**GENOA CHARTER TOWNSHIP  
PLANNING COMMISSION  
PUBLIC HEARING  
JUNE 12, 2023  
6:30 P.M.  
AGENDA**

<b>Attention:</b>	Amy Ruthig, Planning Director
<b>Subject:</b>	Bed and Breakfast Inn – Special Land Use and Sketch Plan Review #1
<b>Location:</b>	7854 Collingwood Drive – south side of Collingwood Drive, west of Grand River Avenue
<b>Zoning:</b>	SR Suburban Residential District

**Re: Collingwood Drive Bed and Breakfast  
Sketch Plan Review No. 1**

PEA THE LEGACY APARTMENT HOMES | PEA JOB NO. 2021-0578 | PUD FINAL SITE PLAN

S:\PROJECTS\2021\0578 LAURENCE GENOA TOWNSHIP\0578 SITE PLANS\C-2.01 P1 DM-21-0076.dwg

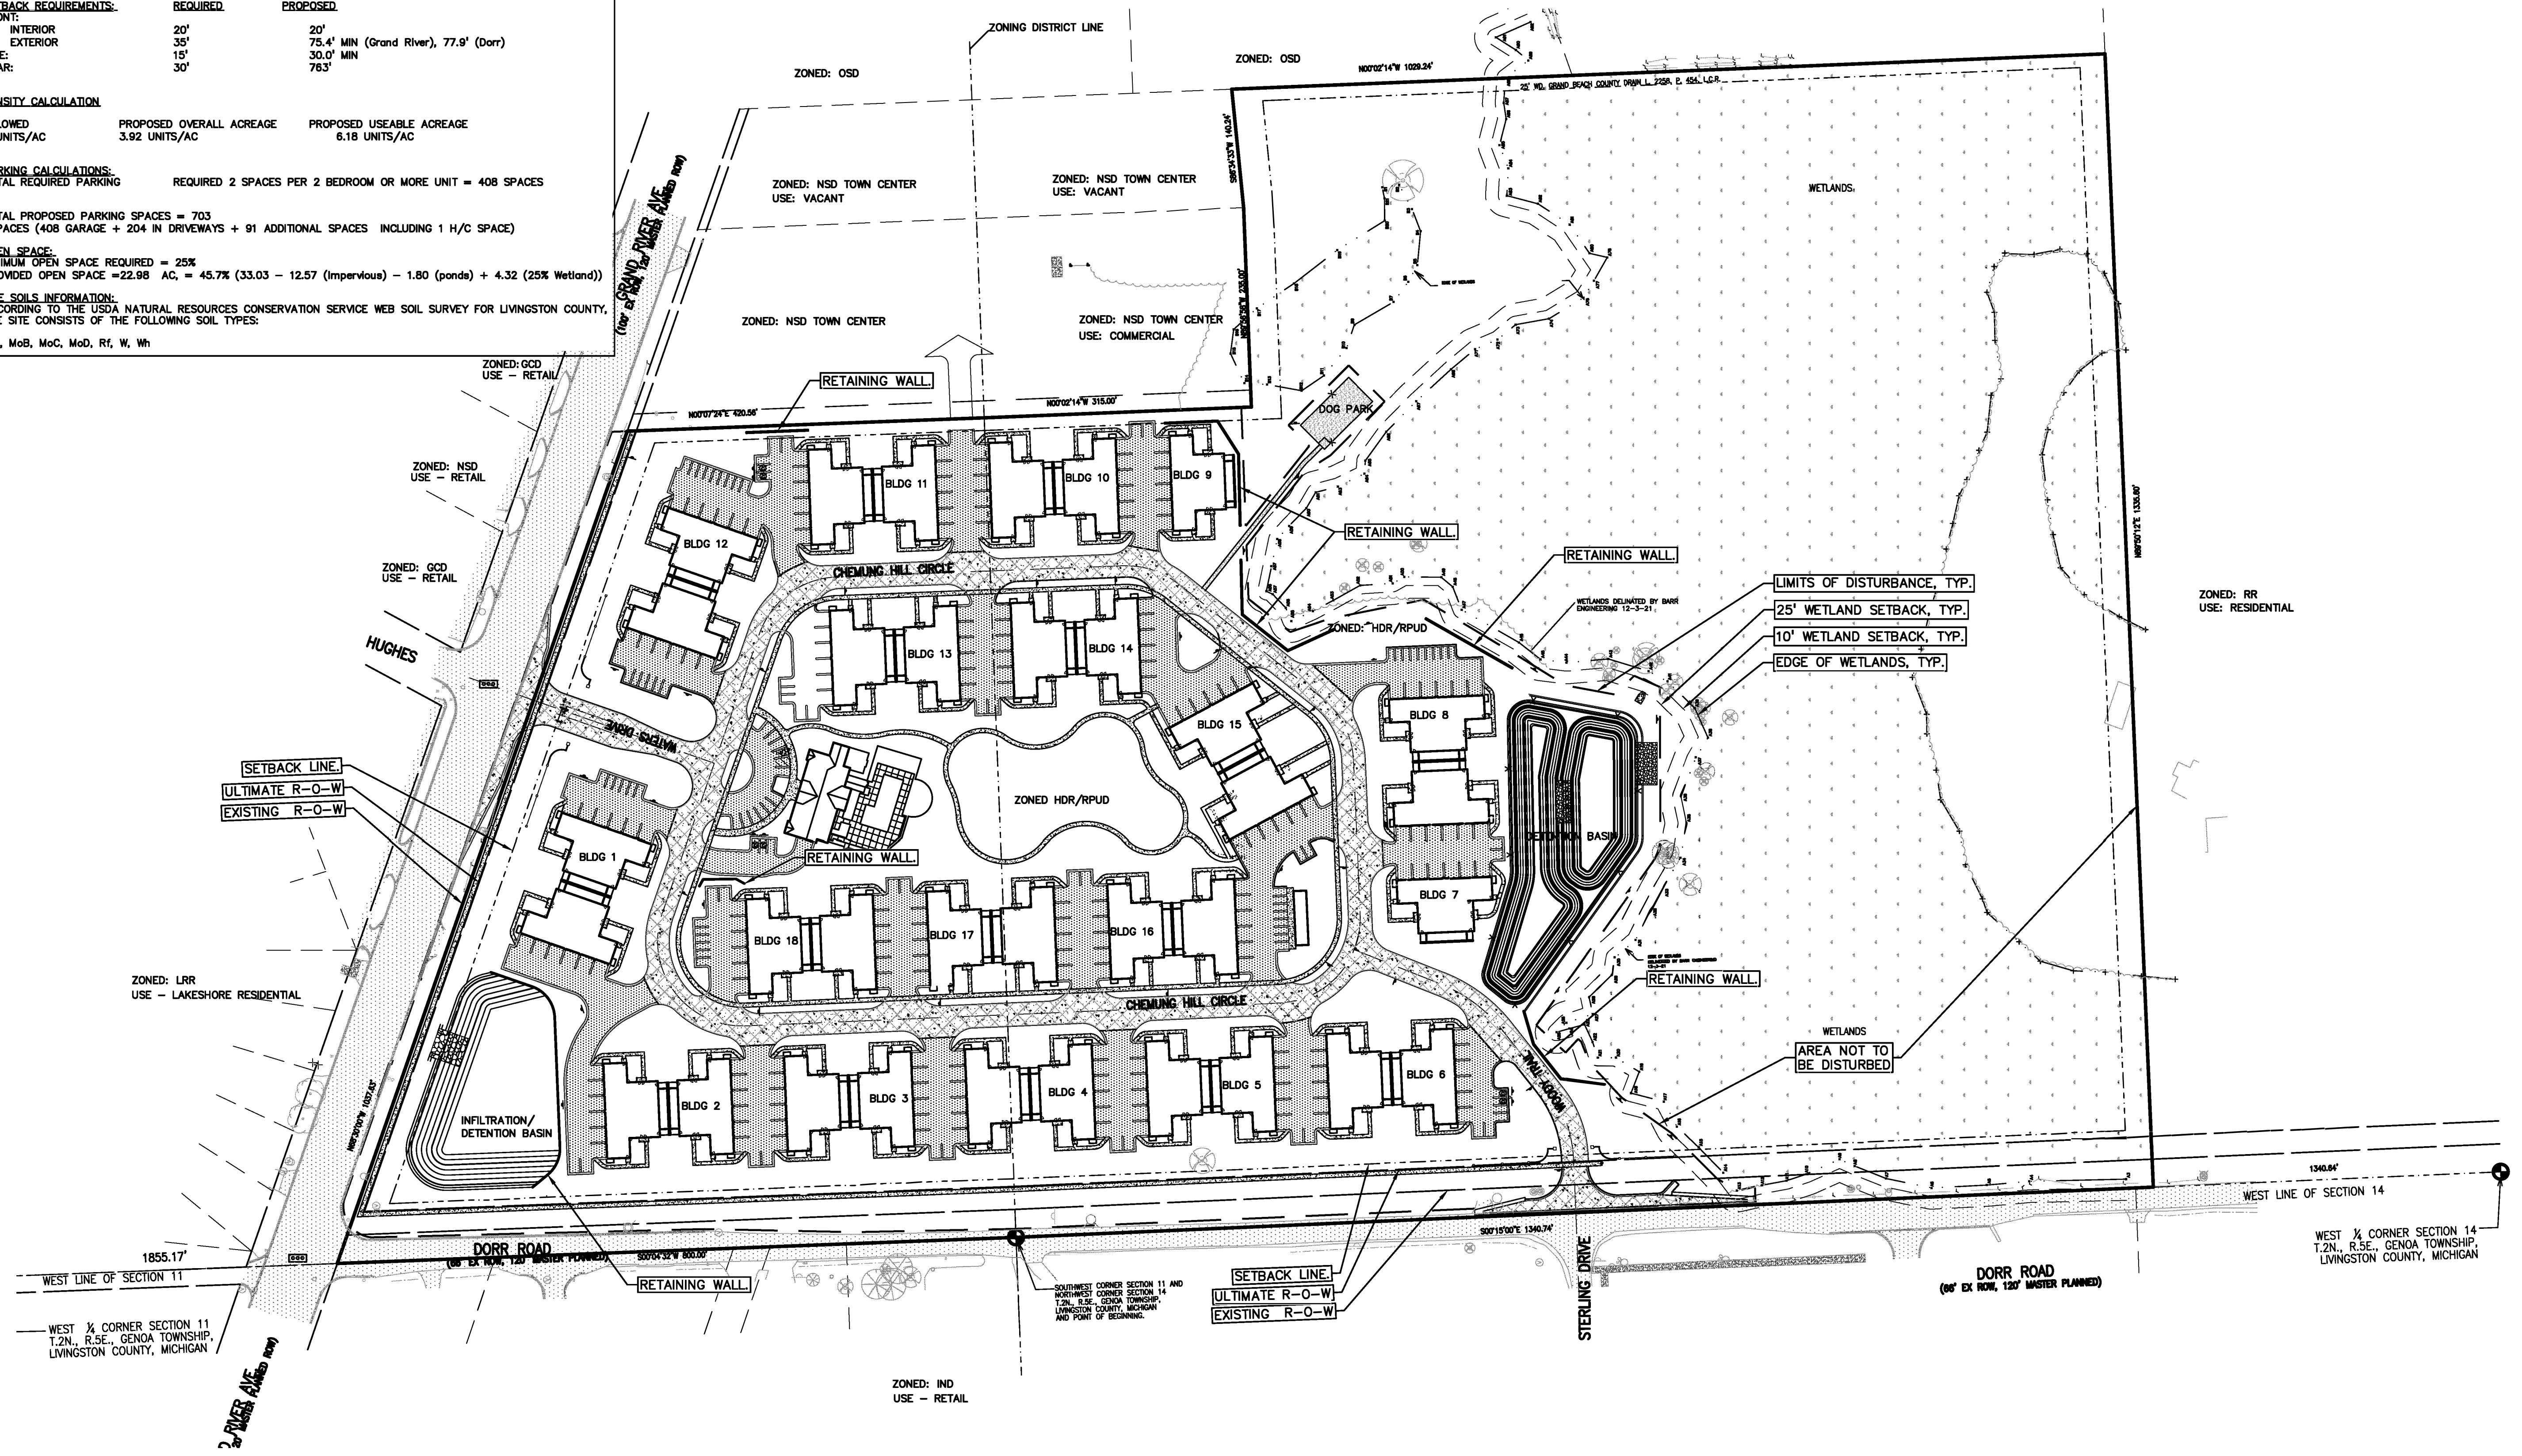
- 9. Refuse Removal.** A note on Sheet C-2.1 states that “trash collection will be provided via individual trash carts for each unit with curb side trash collection.”

ORIGINAL ISSUE DATE:  
 APRIL 10, 2023  
 DRAWING TITLE  
**SITE PLAN NORTH**

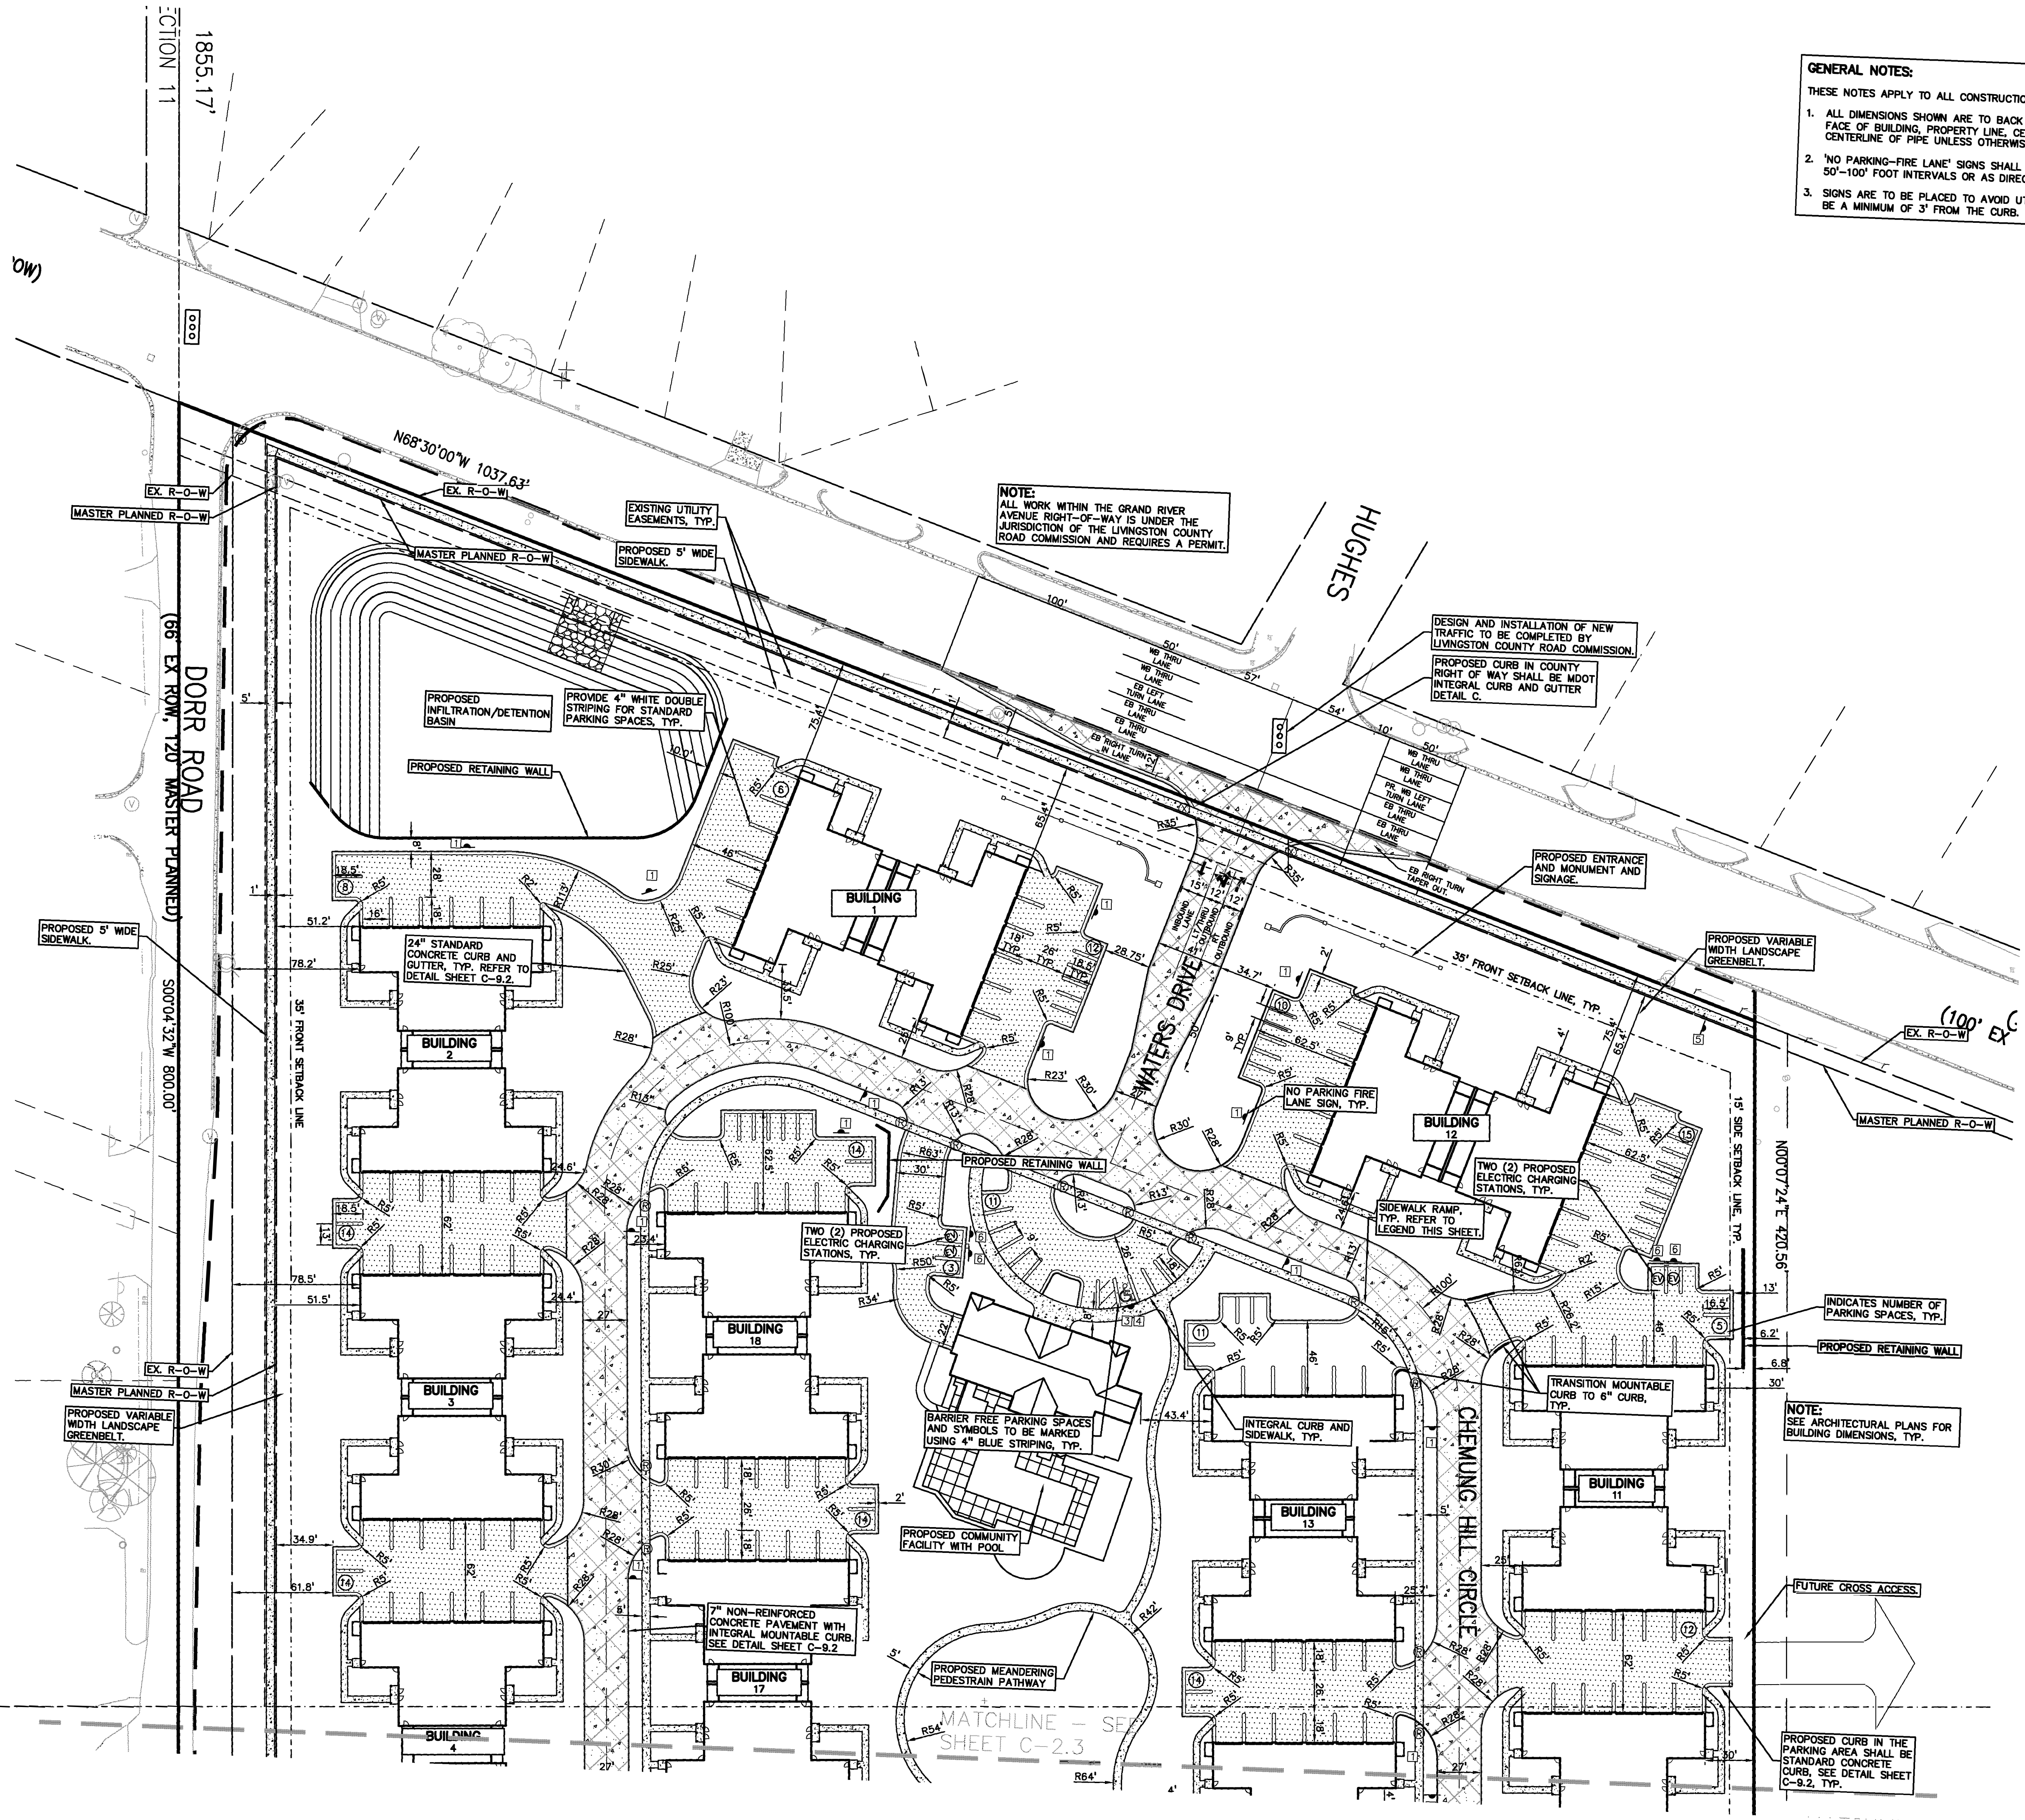
The traffic study recommends an upgraded traffic signal at the Grand River and Hughes intersection. A note on Sheet C-2.2 indicates that design and installation of the new signal will be completed by the Road Commission.

MATCHLINE - SEE SHEET C-6.6

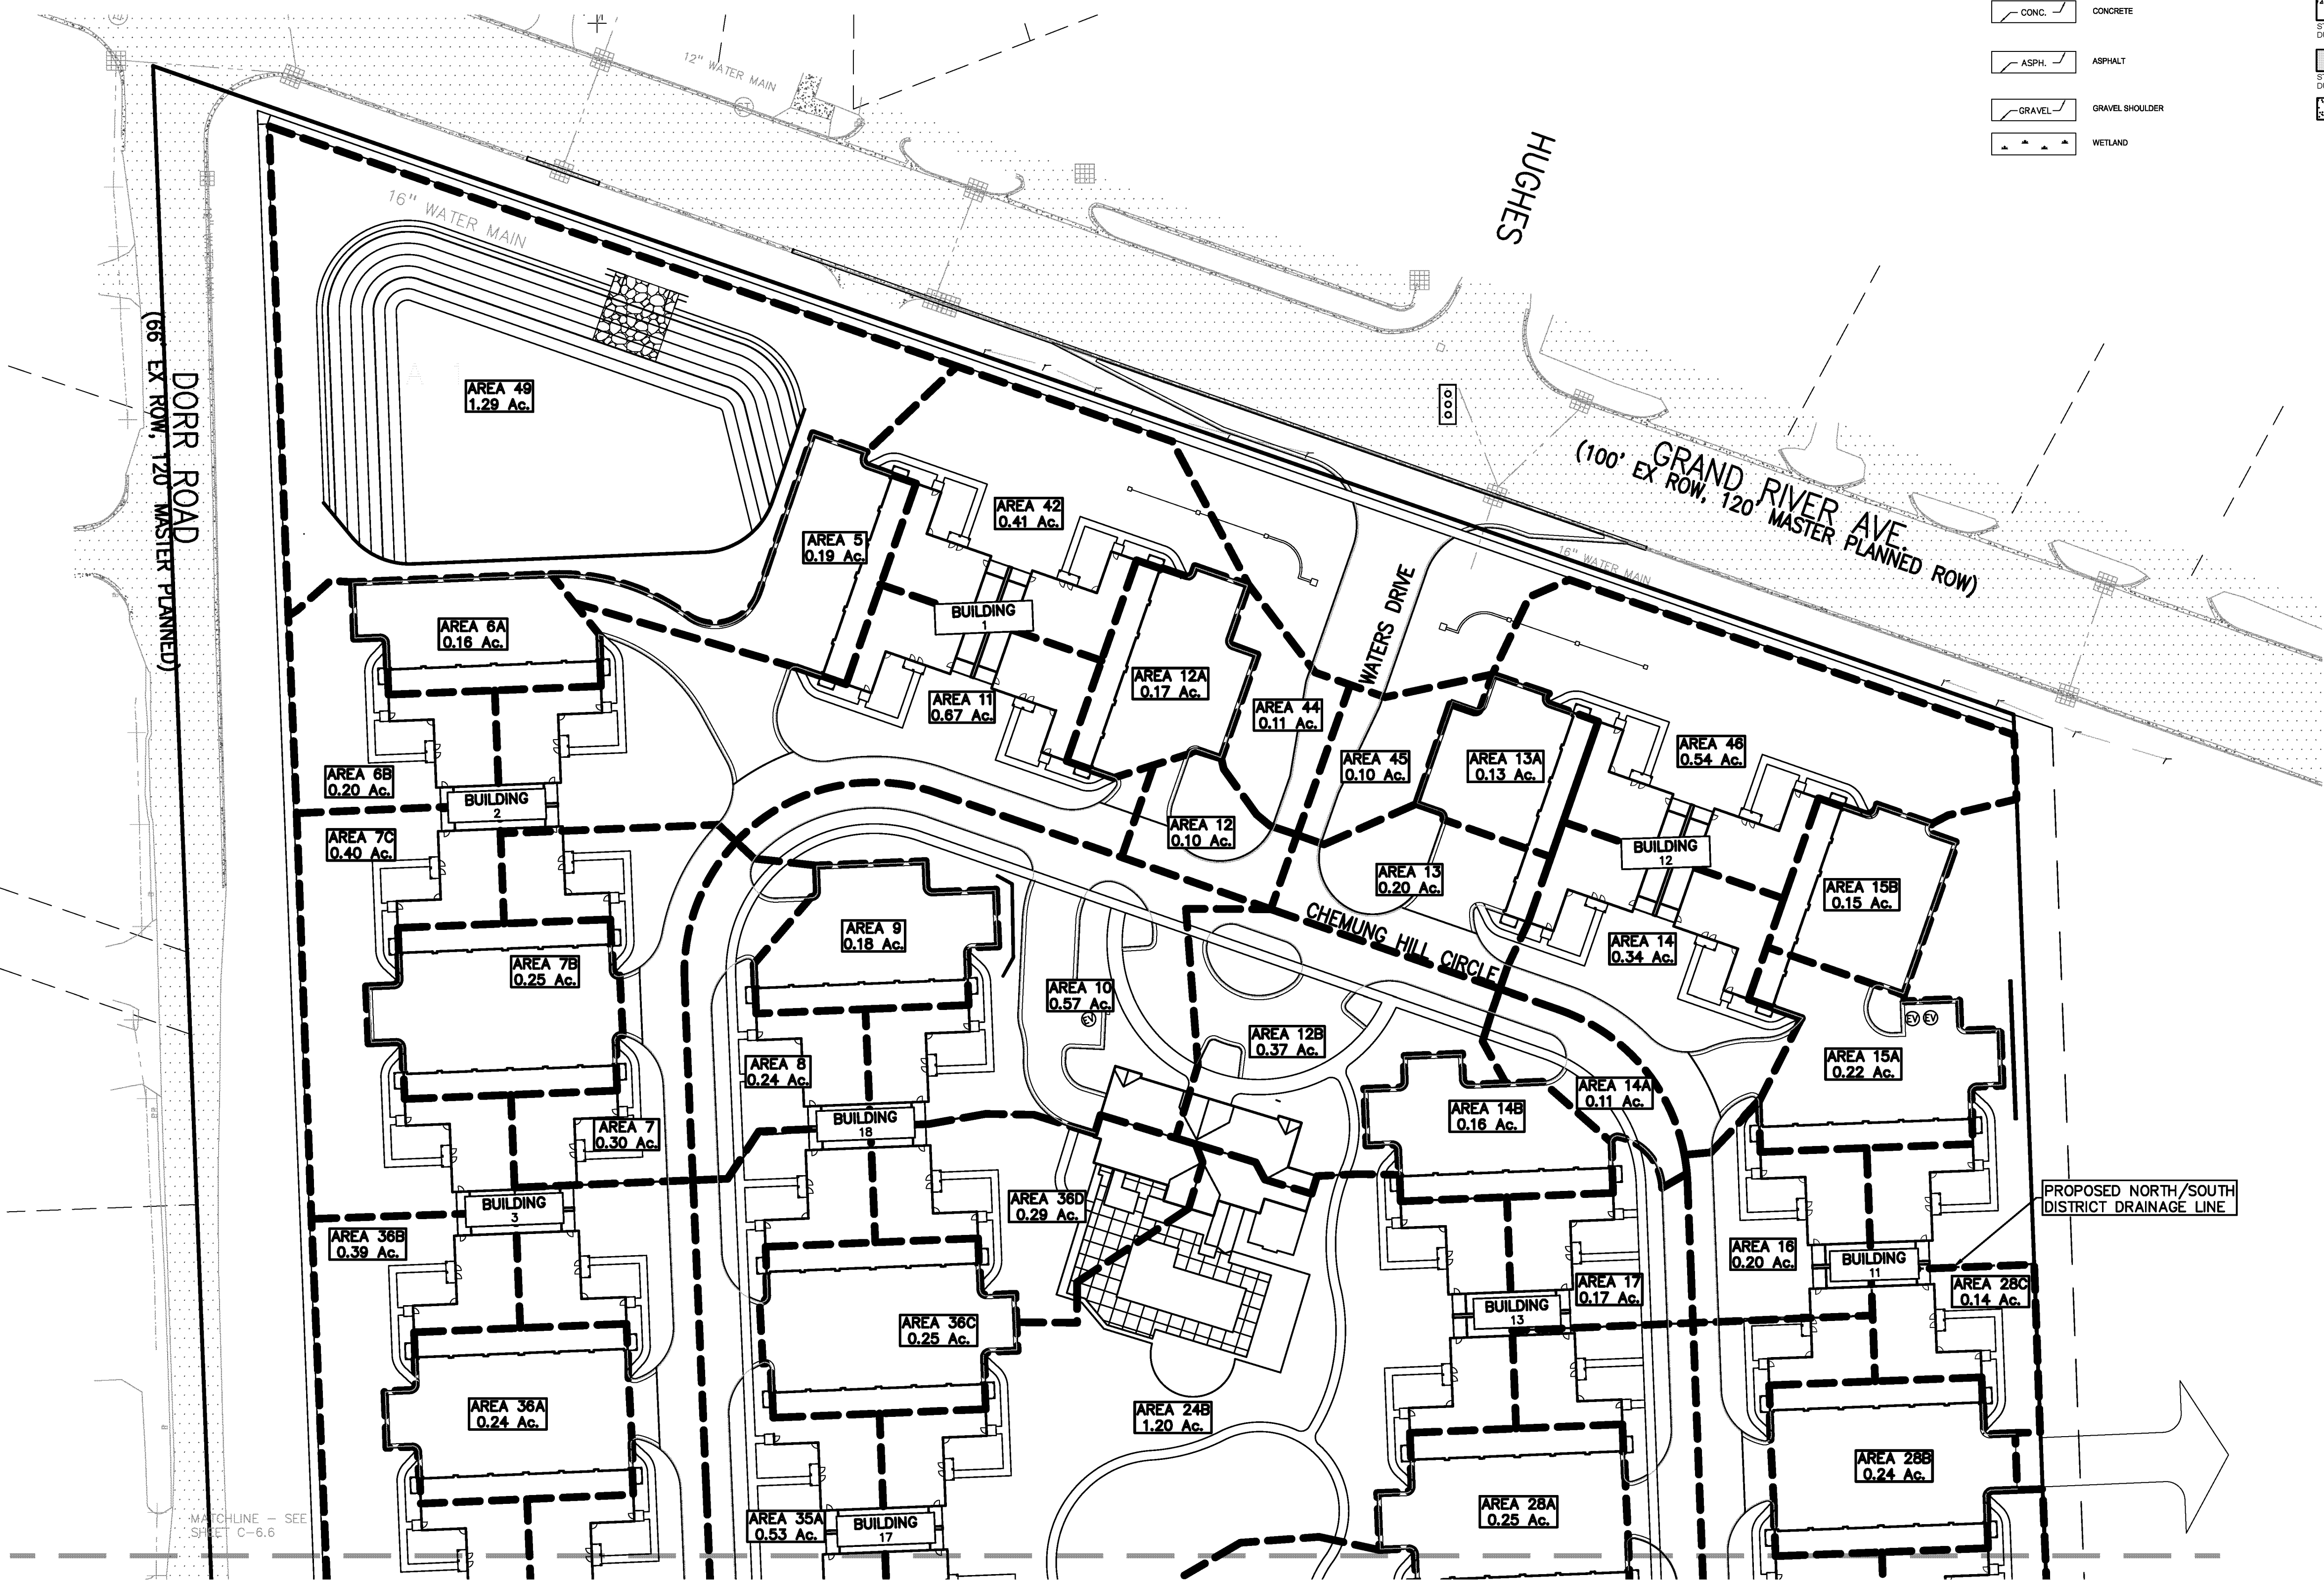
- 4.) Drainage Area Plans - Sheets C-6.5 and C-6.6 should show the drainage area boundaries and acreages of the tributary areas encompassing the North and South Detention Basins. It appears that part of the tributary area containing the South Basin has not been accounted for in its design. It also appears that the drainage boundary lines along Dorr Road should be shifted to its Master Planned Right-of-Way line and the scale noted on Sheet C-6.5 should be corrected.
